City of El Paso – City Plan Commission Staff Report

Case No:	PZRZ12-00022 (Reconsideration)
Application Type:	Rezoning
CPC Hearing Date:	April 18, 2013
Staff Planner:	Andrew Salloum, 915-541-4633, salloumam@elpasotexas.gov
Location:	2413 Tremont Avenue
Legal Description:	Lots 9-14, Block 25, Third Amended Map of Highland Park Addition, City of El Paso, El Paso County, Texas
Acreage:	0.413-acre
Rep District:	2
Existing Zoning:	R-5 (Residential)
Existing Use:	Vacant
Request:	From R-5 (Residential) to S-D (Special Development)
Proposed Use:	Apartment Complex
Property Owner:	Hector F. Barraza
Representative:	Jorge Avila

ATTACHMENT 3: CONCEPTUAL SITE PLAN

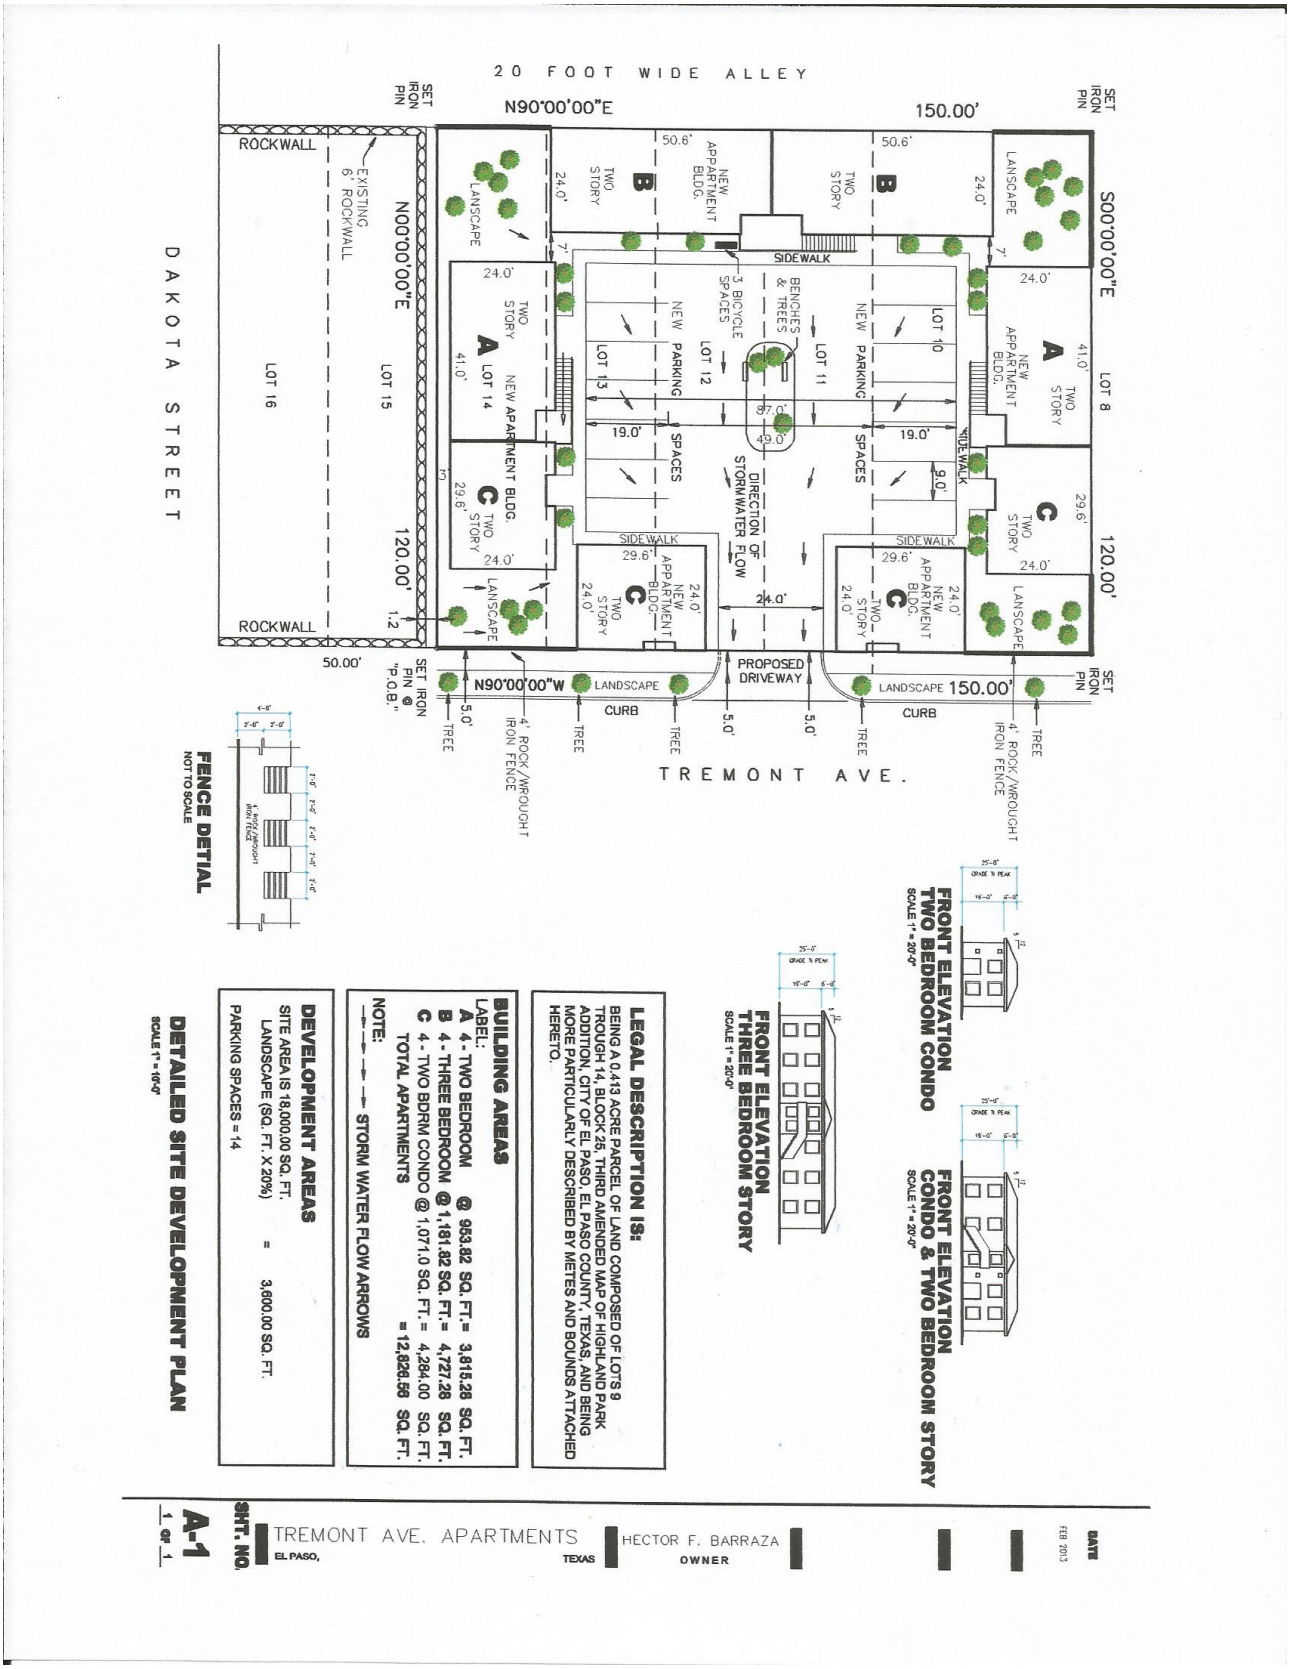
Site Plan Comments:
1. Provide number of apartment units to ensure parking requirements are met.
2. Bicycle racks are required but not shown on the site plan.
